*Re: Revised Addendum  
March 2004 Interim Groundwater  
Investigation Report  
Former Penetrex Processing, Inc.  
Glen Head, New York  
(Site No. 1-30-034)*

P.W. Grosser Consulting Inc. (PWGC) is in receipt of your July 28, 2004 correspondence which provides comments to our proposed soil gas survey work plan. The soil gas work plan was original contained in our initial June 29, 2004 addendum to our March 2004 Interim Groundwater Investigation Report (Interim Report). The Department's comments are addressed below in the order that they appear:

Project: PEN0001	Designed by: JBR	Figure No.: 4
Scale: 1" = 40'	Approved by: JBR	Date: 02/09/04

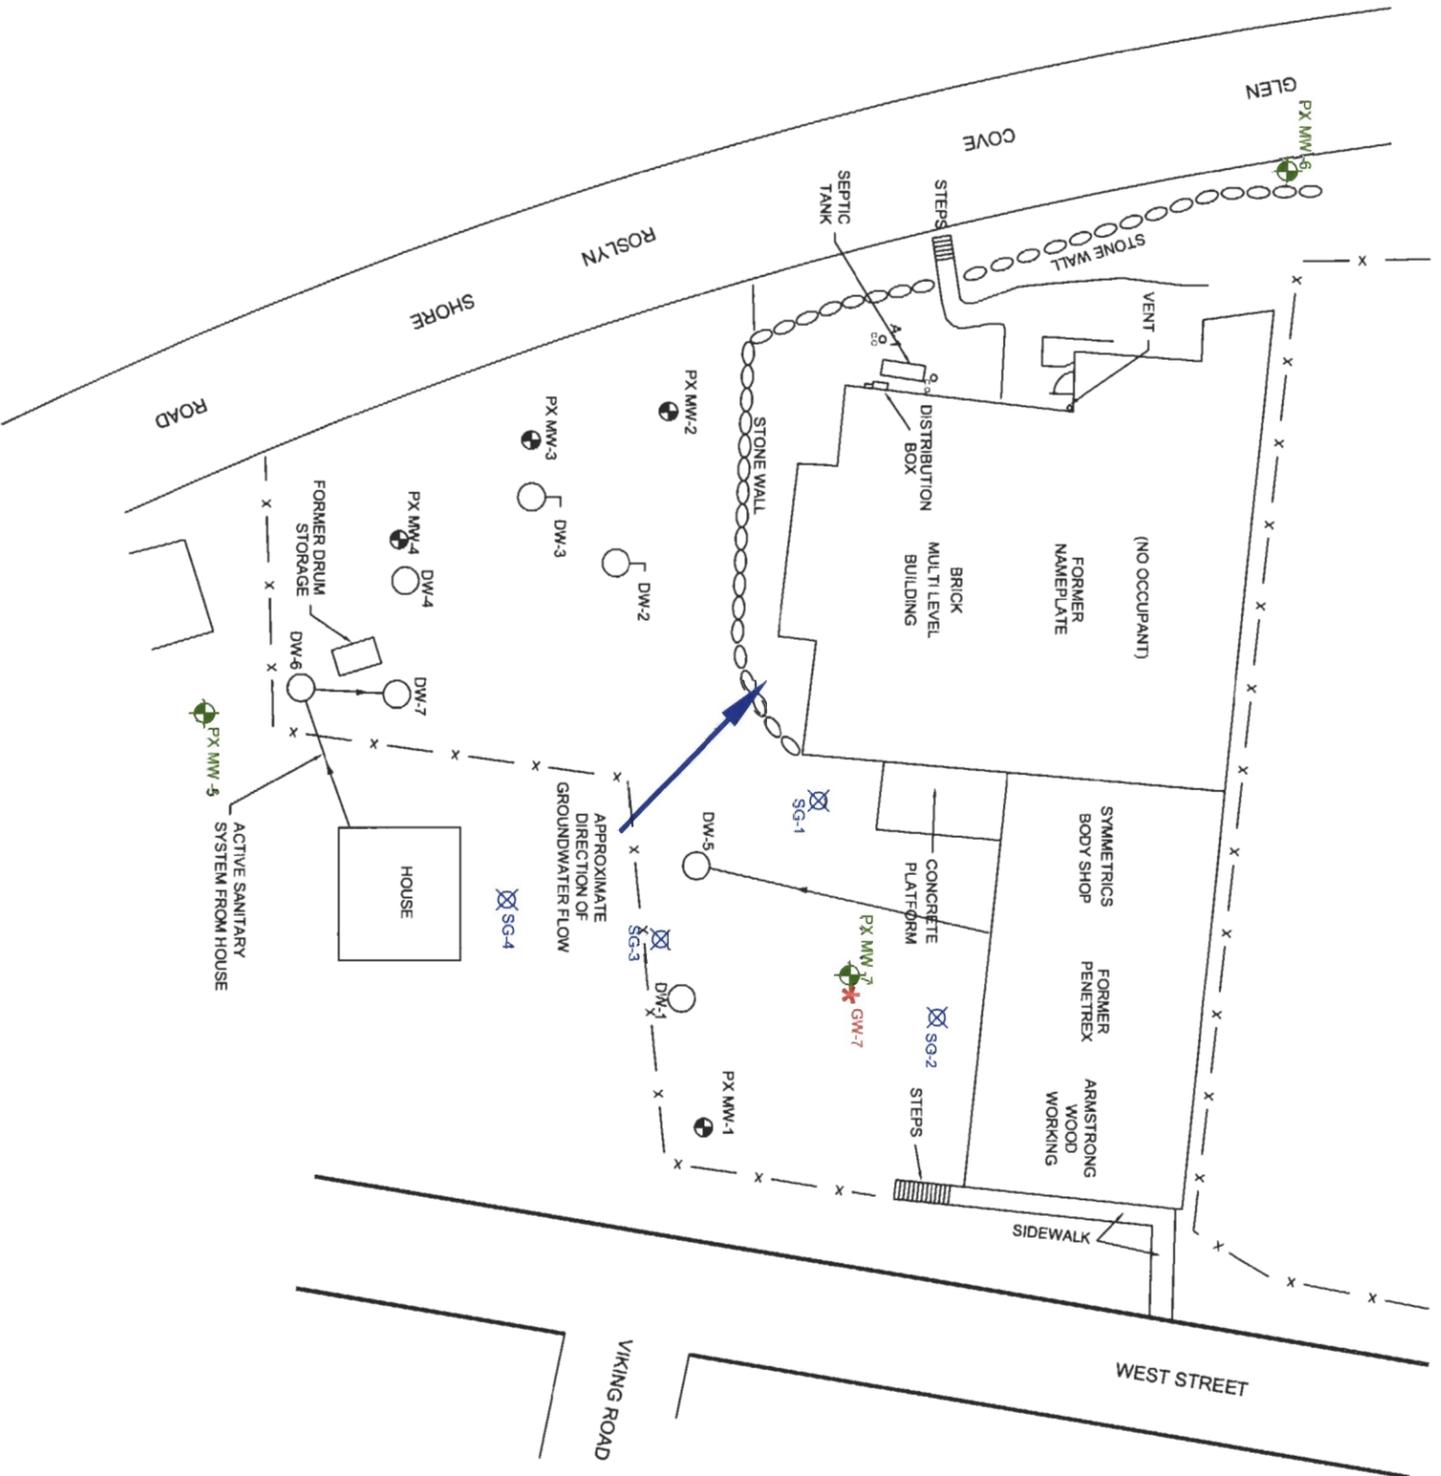
To address the Departments concerns regarding soil vapor intrusion into the adjacent buildings, PWGC will conduct soil gas sampling at four (4) locations. PWGC proposes to conduct soil gas sampling at the following locations:

- SG-1 - 10 feet from the former Nameplate building to avoid the effects from the building and to the west of GW-7.
- SG-2 -10 feet from the former Penetrex building and to the north of GW-7.
- SG-3 - will be conducted at the property boundary between GW-7 and the residence to the south.
- SG-4 - will be conducted 10 feet from the foundation of the residence to reduce effects from the building.

The locations of the soil gas survey points are depicted on Figure 4. Given the relatively close proximity of points SG-1 and SG-2, PWGC does not believes soil gas sampling is necessary between these points and GW-7. The locations depicted on

Figure 4 are preliminary and may have to be moved slightly depending on access issues. Final locations will be discussed with the NYSDEC prior to the actual sampling.
